Subject: Three Mile Island Nuclear Station, Unit 1 (TMI-1)  
Operating License No. DPR-50  
Docket No. 50-289  
Additional Information in Response to Generic Letter (GL) 95-03  
"Circumferential Cracking of Steam Generator Tubes"

GPU Nuclear Response to Generic Letter 95-03 Request for Additional Information

FIGURE 1

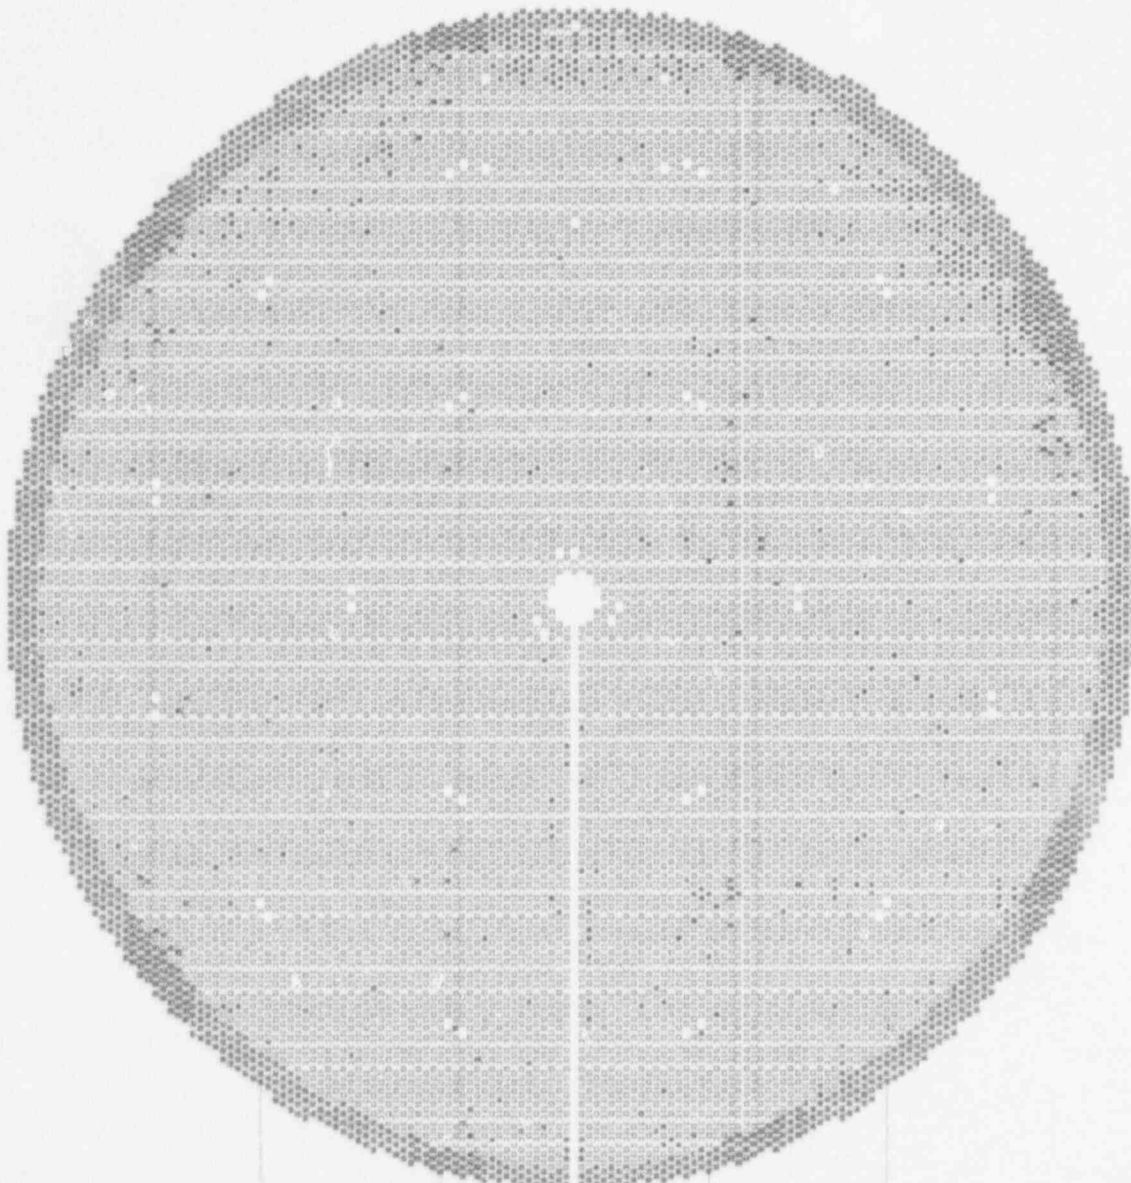
EPRI report NP-6201 indicates that the 15th TSP contains both broached holes and drilled holes, the drilled holes being prone to denting. Please clarify whether all of the tube support plates are of the broached hole designs or whether a number of them contain drilled locations, if applicable, or if it has been observed at other support plate intersections (i.e., broached holes).

The outer tube locations in the 15th tube support plate (TSP) at all units are drilled to a .637" minimum / .646" maximum diameter. Approximately 1621 locations are typically drilled. At TMI-1 1626 locations are drilled in the 15th TSP as shown on Figure 1. All remaining locations at this support plate, and all locations at the other support plates, are broached as described in the GL 95-03 response.

As stated above in response to question #1, at TMI-1 all support plate holes are broached except for 1626 holes in the peripheral holes of the 15th TSP where the holes have been drilled only (See Figure 1).

FIGURE 2A

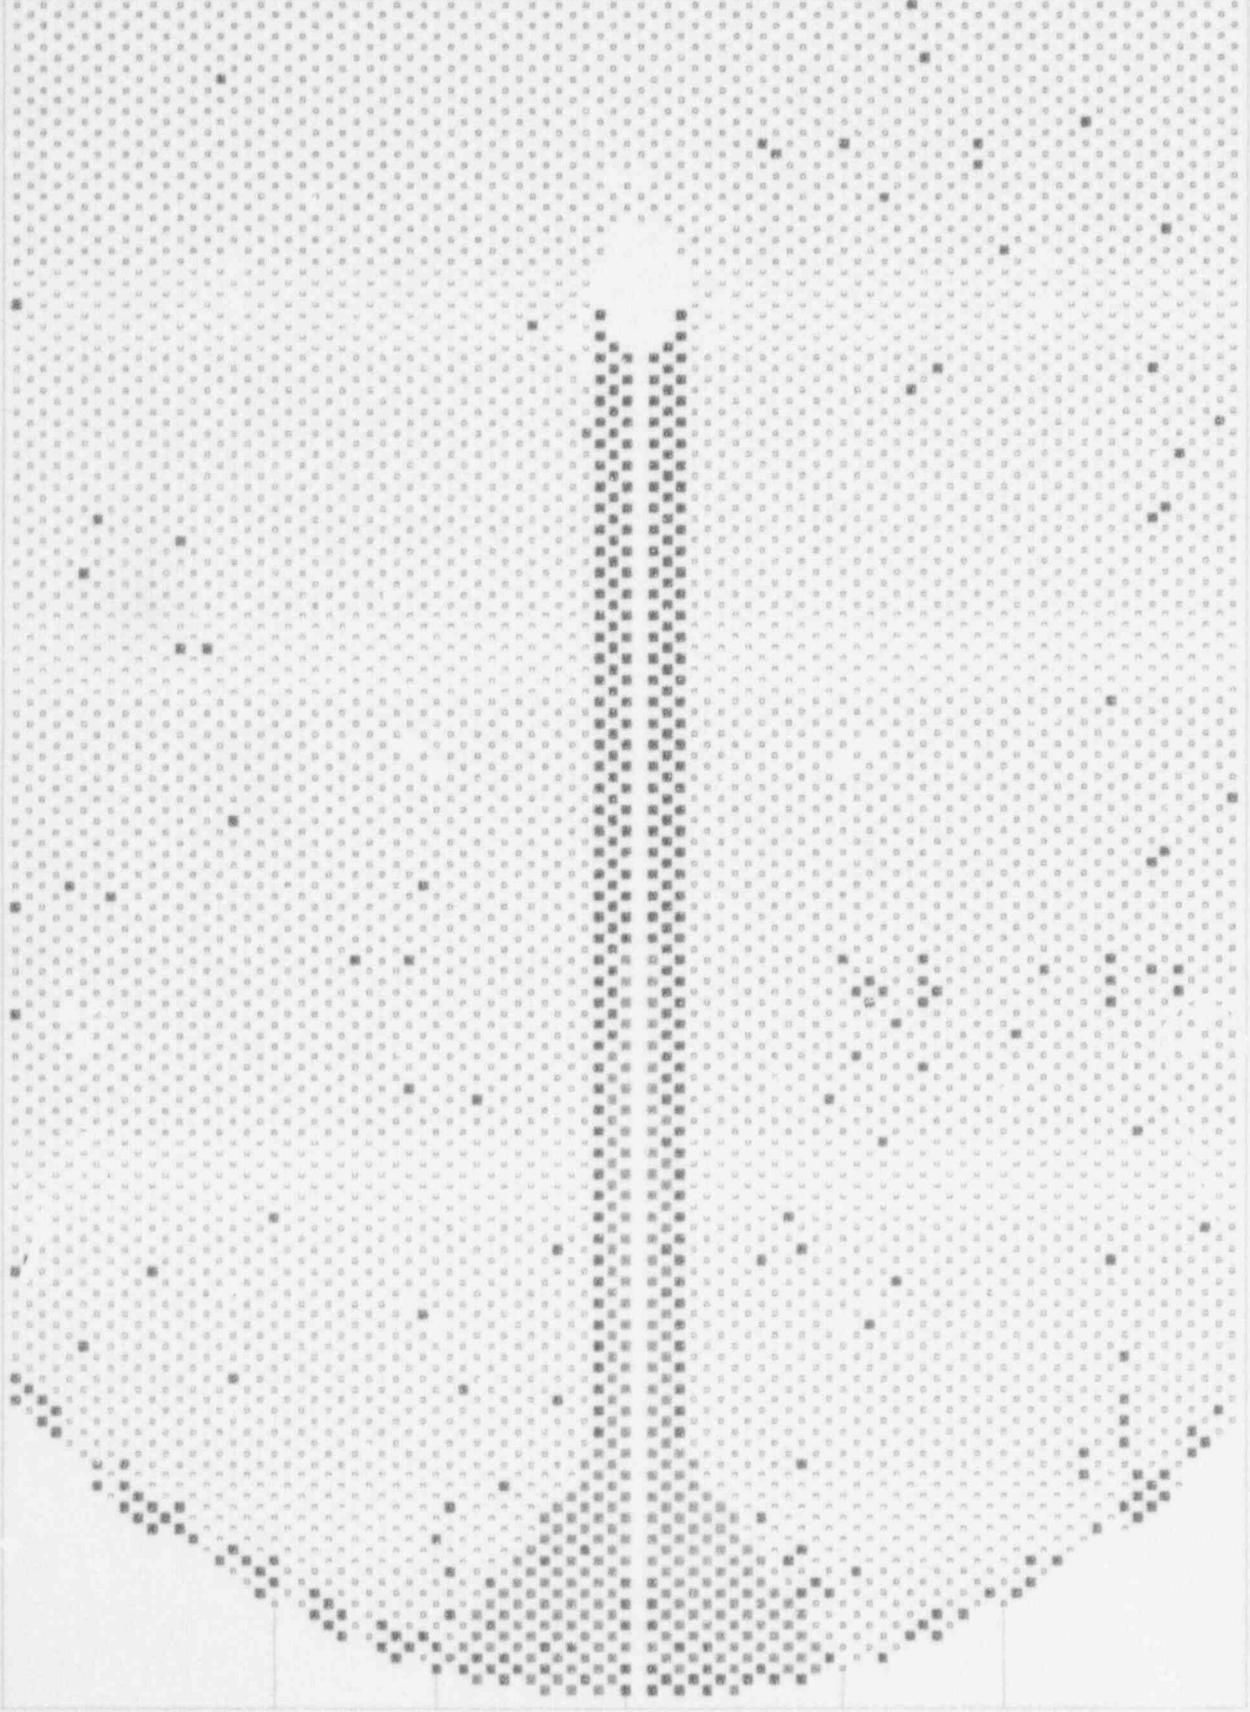
- 1) Please clarify if all tubes in the lane/wedge region have been sleeved at TMI-1.

Tubes along the inspection lane, including an area that fans out at the periphery, are referred to as the lane/wedge region. TMI-1 Tech Spec §4.19.2.a.4(1) defines a group of tubes in the lane/wedge region as "Group A-1," which, along with another group of tubes, may be excluded from the first random sample if all tubes in that group in both steam generators are inspected. Group A-1 is sometimes referred to as the "Tech Spec defined lane/wedge." Un-sleeved tubes in the TMI-1 Tech Spec defined lane/wedge areas of OTSG "A" and "B" are shown in red on Figures 2A and 2B respectively.

The "TMI-1 defined repair lane/wedge" is a region where engineering analysis and OTSG history review has determined that high cycle fatigue cracking is most likely to occur. All in service tubes in the "TMI-1 defined repair lane/wedge" have been sleeved. These tubes are shown in green on Figures 2A and 2B respectively.

FIGURE 3A

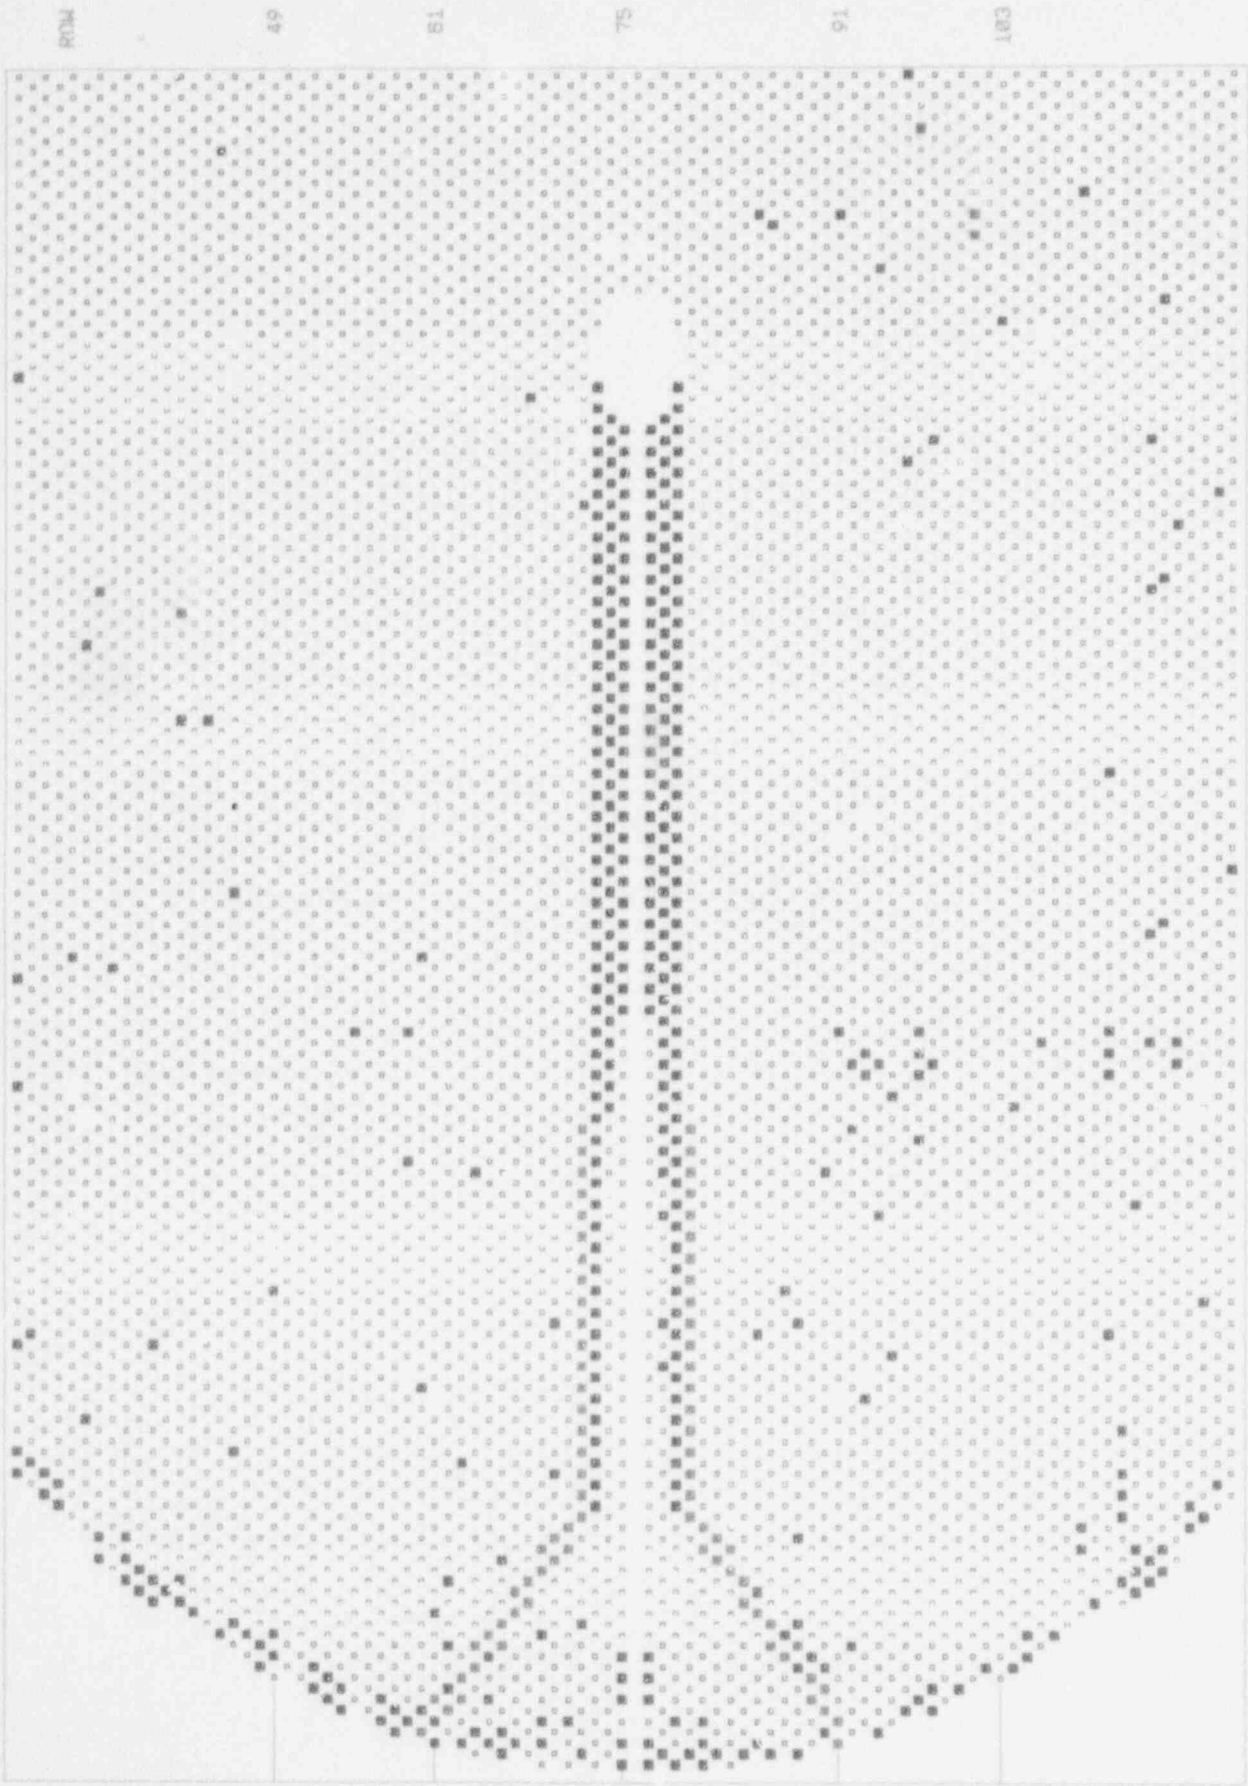
- 2) Please describe the basis for limiting the inspection to the lane region.

- a. Clarify the inspection scope in the lane/wedge region during the last steam generator tube inspections (including the probe type and number (and/or percentage) of tubes inspected).

Figures 3A and 3B show the 589 tubes where 3-coil MRPC examination of the kinetic expansion was performed during 11R. These tubes were chosen because they should be the first to exhibit high cycle fatigue cracking based on highest main steam cross flows and proximity to the previous historical OTSG high cycle fatigue failure locations.

Figures 3A and 3B show the lane/wedge tubes which were examined with the 3-coil MRPC technique during 11R. The 3-coil head contained 0.115" pancake, axial and circumferentially wound coils.
